Product Change Notice (PCN)

Subject: Add Alternate Fab Location

Publication Date: 6/30/2026

5PB1102PGGI/5PB1102PGGK/5PB1104PGGI/5PB1104PGGK

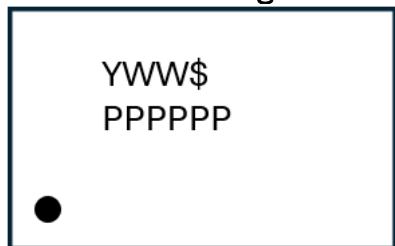
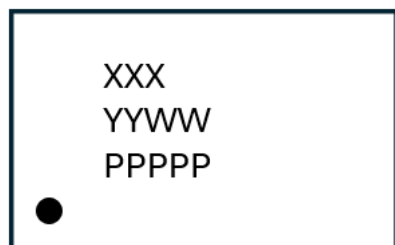
- Line 1: Y = Last digit of the year
 - WW = Workweek
 - \$ = Single Char assembly code Line
- Line 2: Truncated Product Name

5PB1102CMGI/ 5PB1102CMGK/5PB1104CMGI/
5PB1104CMGK

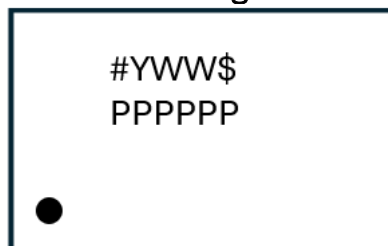
- Line 1: Truncated Product Name
- Line 2: Y = last digit of year
 - W = Single character work week
 - ** = 2-char sequential code

5PB1102PGGI/5PB1102PGGK/5PB1104PGGI/5PB1104PGGK

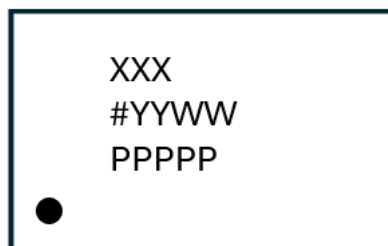
Refer to the top mark stepping number “#” as outlined in the Affected Product List table. Renesas is revising the marking format for parts that do not presently contain a stepping number:

- Line 1: # = Device stepping
 - Y = Last digit of the year
 - WW = Workweek
 - \$ = Single Char assembly code Line
- Line 2: Truncated Product Name
